Technical Note			
Project Number	MA21107	Date	18/01/2022
Responses to the HSE Consultation – OFR Responses

OFR Consultants (OFR) have been appointed by Latimer Developments Ltd to provide fire engineering services for the proposed new Boddingtons Development in Manchester. As part of these services OFR have developed a fire safety strategy that includes the provision of a Fire Statement forming part of the Planning Application (reference: 132416/FO/2021).

This note provides OFR's responses to the HSE Consultation to the Local Planning Authority (reference: pgo-0676, dated 11/01/2022).

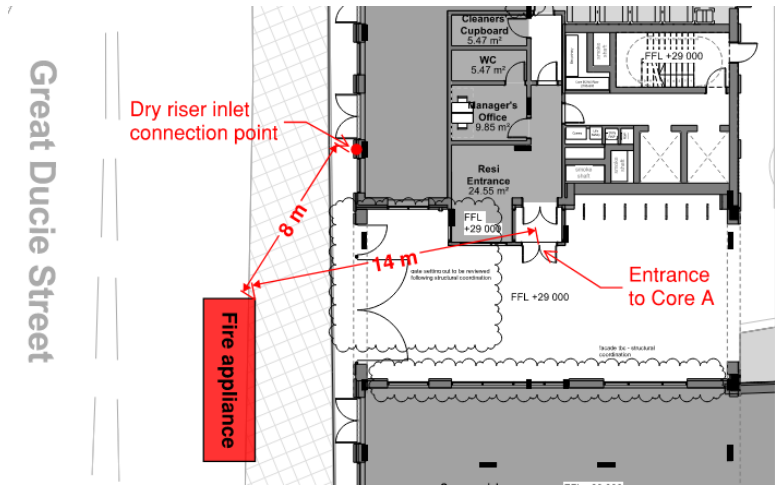
2.4	Fire engine access to Block A is stated to be from Great Ducie Street, passing under the first floor of Block A. The LPA may wish to consult with the local Fire Rescue Service to ascertain the headroom their fire appliances require as it	The fire appliance will park on Great Ducie Street and will not pass under Block A to access the entrance to the core. Parking on Great Ducie Street. This allows

may be more than 3.7m. This may impact on the design, appearance and materials used.	access to within 18 m of the dry riser inlet connection point (which will also be visible and clearly signed) and within 18 m of the entrance to the Block A core. See figure below.
